BRUNSWICK STEAM ELECTRIC PLANT, UNIT NO. 1
DOCKET NO. 50-325/LICENSE NO. DPR-71
REQUEST FOR LICENSE AMENDMENT
FUEL CYCLE 11 RELOAD LICENSING

BRUNSWICK STEAM ELECTRIC PLANT, UNIT 1
NRC DOCKET NO. 50-325
OPERATING LICENSE NO. DPR-71
REQUEST FOR LICENSE AMENDMENT
FUEL CYCLE 11 RELOAD LICENSING

SODIUM PENTABORATE SOLUTION
VOLUME CONCENTRATION RANGE COMPARISON

SODIUM PENTABORATE SOLUTION VOLUME CONCENTRATION RANGE COMPARISON

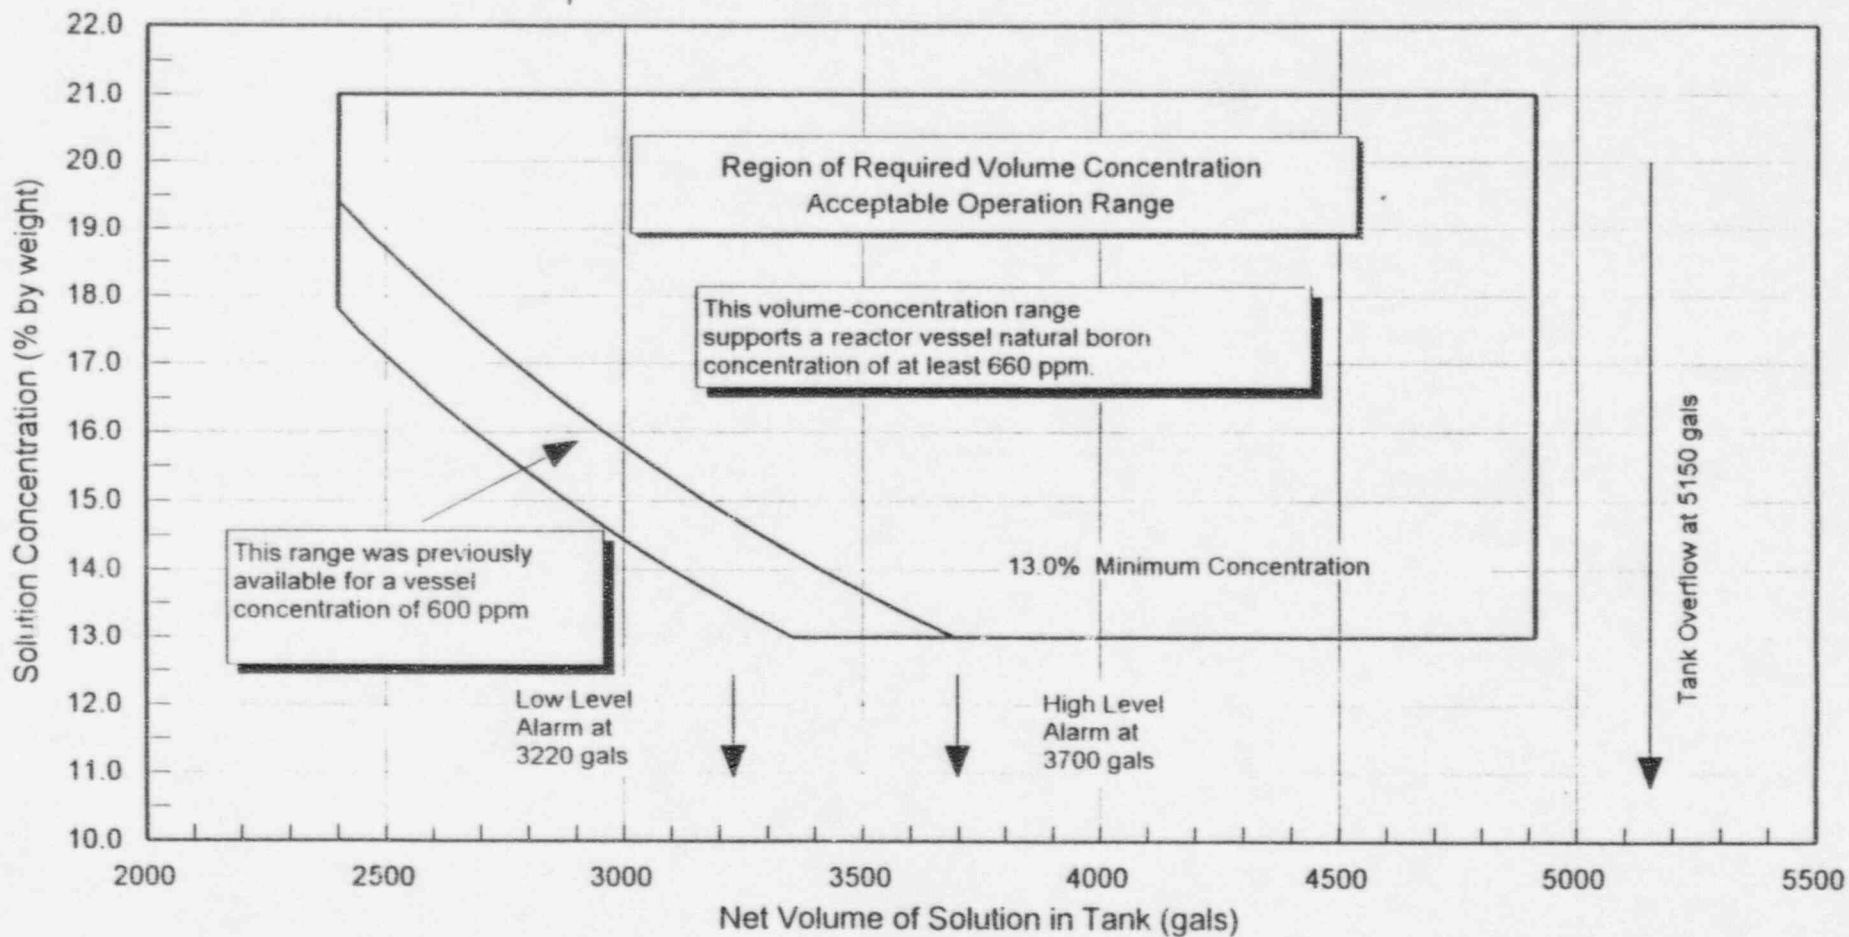
Revise the acceptable sodium pentaborate volume-concentration range for the standby liquid control system shown in Technical Specification Figure 3.1.5-1 to reflect changes to poison

material concentration needed to achieve reactor shutdown based on planned use of the new GE13 fuel type.

The portion of the sodium pentaborate concentration range shown in Technical Specification Figure 3.1.5-1 applicable to the lower range of tank volumes is being revised to increase the required concentration of sodium pentaborate solution. This change is needed to account for the additional shutdown reactivity needed based on the planned use of GE13 fuel assemblies as reload fuel for the Unit 1 reactor core. Since the standby liquid control system is independent from the normal means of controlling reactor core reactivity and not used to control core reactivity during normal plant operations, the proposed revision to the sodium pentaborate concentration curve for the standby liquid control system does not alter any plant safety-related equipment, safety function, or plant operations that could change the probability of an accident.

As previously stated, the purpose of the standby liquid control is to inject a neutron absorbing solution into the reactor in the event that a sufficient number of control rods cannot be inserted to maintain subcriticality. Sufficient solution is to be injected such that the reactor will be brought from maximum rated power conditions to subcritical over the entire reactor temperature range from maximum operating to cold shutdown conditions. General Electric methodology establishes a fuel type dependent standby liquid control system shutdown margin to account for calculational uncertainties. General Electric calculations show that an in-vessel concentration of 660 ppm will provide a standby liquid control system minimum shutdown margin in excess of the 3.2% Δk value required for the GE13 fuel. To achieve an in-vessel concentration of 660 ppm, the acceptable range of standby

liquid control system tank concentrations is being revised for the lower range of tank volumes. Thus, the proposed revision of the standby liquid control system sodium pentaborate volume-concentration range ensures that there will not be a significant reduction in the amount of available shutdown margin and, therefore, not a significant reduction in the margin of safety.

During normal operations, the standby liquid control system tank concentration is maintained in a range from approximately 16 percent to 17 percent to provide sufficient margin to avoid the occurrence of a dilution/precipitation event. If the minimum concentration at the tank low level alarm (3,220 gallons) is raised from 13.4 percent to 14.8 percent, the tank concentration for normal operation would need to be maintained above this range to provide margin between the working concentration and the Technical Specification limit.

The proposed SLCS tank volume-concentration range falls within the current acceptable range specified by Technical Specification Figure 3.1.5-1. The change in volume-concentration range, for one or two pump operation, would still result in SLCS injection times within the ranges stated in the Updated FSAR. Also, increasing the minimum sodium pentaborate volume-concentration does not require a change to the SLCS minimum pump flow rates (for one pump operation, as stated in Technical Specification 4.1.5.c.2).
